From: Brian Greenwood [REDACTED]
Sent: 02 August 2012 16:44
To: Mike Harris
Cc: Able Marine Energy Park
Subject: TR030001 - Associated British Ports [REDACTED] - proposed Able marine energy park - comments and further representations

Application for the proposed Able Marine Energy Park on the south bank of the River Humber at Immingham, North Lincolnshire

**Response to Comments on Relevant and Written Representations and 1st Round Examiner
Questions on Marine Matters**

Figure PW1

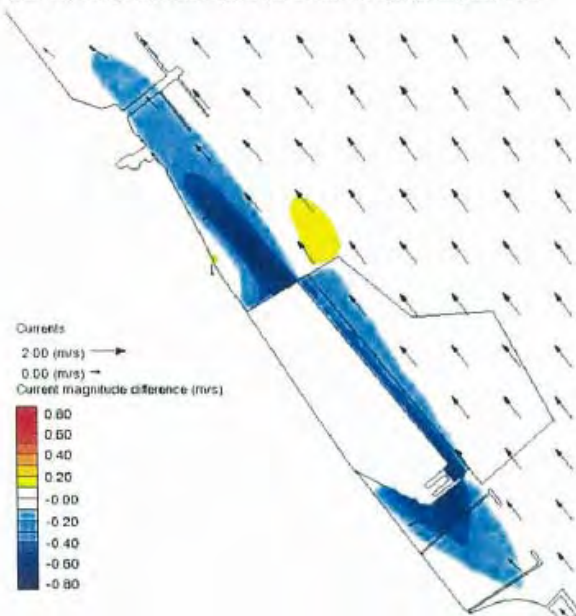
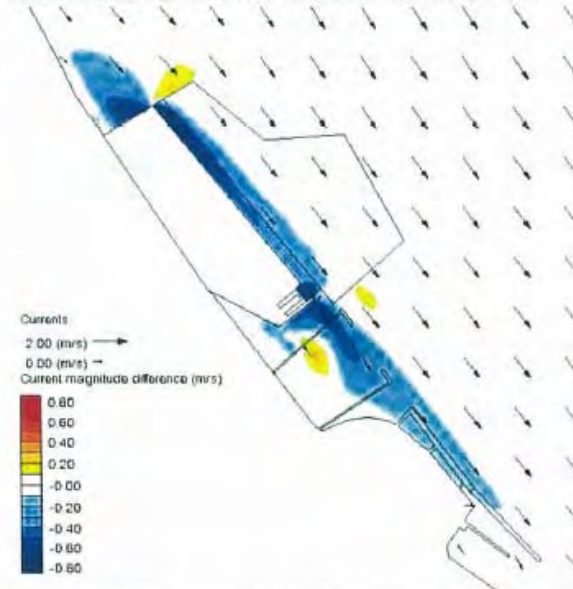
- 1.5. The Sunk Dredged Channel (SDC), see Figure PW1, is a critical passage for large vessels navigating to and from ABP and other estuary users facilities. It has a cyclic pattern of sedimentation with a consequent maintenance dredging requirement. The current status is that of a self-maintaining channel but it is reaching a point in the cycle when sedimentation is expected to rapidly increase. The last peak in sedimentation (1996/7) was so severe that for several months not even the continuous operation of two dredgers was able to keep the channel open for vessels at the previously maintained depth. Since that time, vessels have generally become larger and the Humber International Terminal (HIT) has been opened, hence more vessels requiring transit through the channel. The proposed annual volume of maintenance dredge arisings from the Able development to be deposited at HU080 (Middle Shoal) would substantially increase the risk that the SDC during the next period of peak sedimentation would be unavailable for vessels for a longer period of time. It is not possible to calculate the precise effect, but based on the relative increase in volume that is likely to be deposited during the peak sedimentation period it is estimated that the maintenance dredging requirement in the channel may be increased by 15 to 20%. Even more critical for vessel management will be the increase in rate of sedimentation (loss in depth) and the rate at which this can practically be removed. This would directly impact on access to the Port of Immingham for larger vessels and, unless comprehensively safeguarded, may leave the Port severely disadvantaged by Able's proposals.

FIGURE PW3

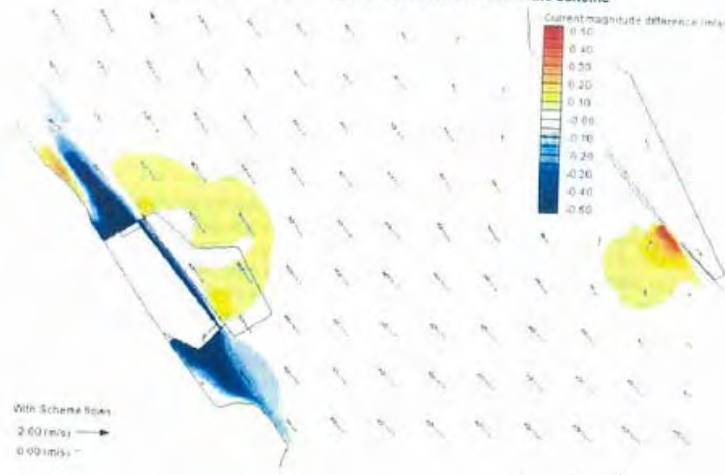
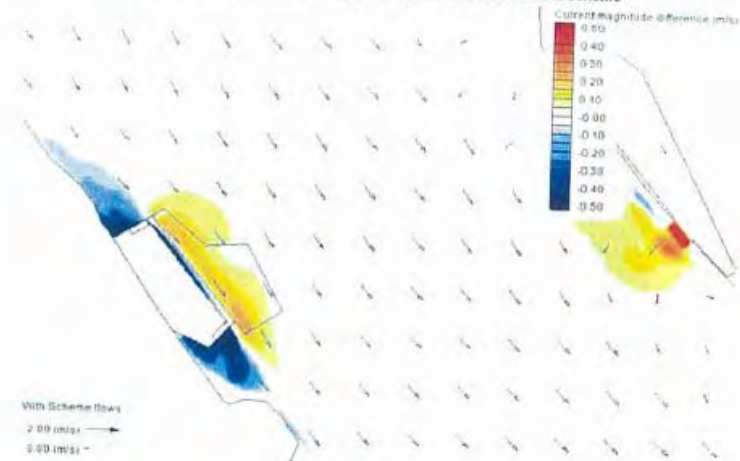
- 3.6. I observe that the applicant now notes ABP's concerns with respect to IOH. The applicant, however, still makes no comment about whether IOH was actually modelled in the baseline hydrodynamics.
- 3.7. A comparison of the June 2012 modelling results at Figures 3.9 and 3.10 of supplementary report EX 8.7 with the equivalent Figures 15 and 16 in the original ES demonstrates that IOH was not included in the original modelling. This is further substantiated by:
- Firstly, IOH was not shown or recognised as a sensitive receptor in the original ES; and
 - Secondly the pattern of change in the later modelled version is very different; see the attached Figures PW2 and PW3.

- 3.8. The argument put forward for no increase in sedimentation in IOH might be credible if the local baseline hydrodynamics had been correctly modelled and IOH had been correctly represented in the model. This does not, however, appear to be the case and the queries raised by ABP in this respect have not been answered by the applicant's response. If it had been included I would have expected to see the data from the model. This has not been provided.
- 3.9. The new report, EX8.7, is an attempt to justify the assertion that there will be no effect on IOH. However, comparison of equivalent diagrams from this new report and the original modelling presented in the ES, (Figures PW2 and PW3 respectively attached), show distinctly different

patterns of effect on the local flow regime. Figure PW2 is the new modelling with the DCO development design and Figure PW3 is the ES presented design, which was inferred in the ES as the worst case. It should also be noted that IOH and the jetty structures appear in the new modelling but are absent from the ES. This supports our view in 7.2 (b) of the Relevant Representations that the works have not been correctly reflected in the ES nor properly assessed. As I indicated in Para 1.1, I have not had an opportunity yet to determine whether the new modelling has been properly undertaken and support the assertions made about it and in particular whether it has properly assessed IOH and the jetty structures, assets that are critical to marine operations at the Port of Immingham.
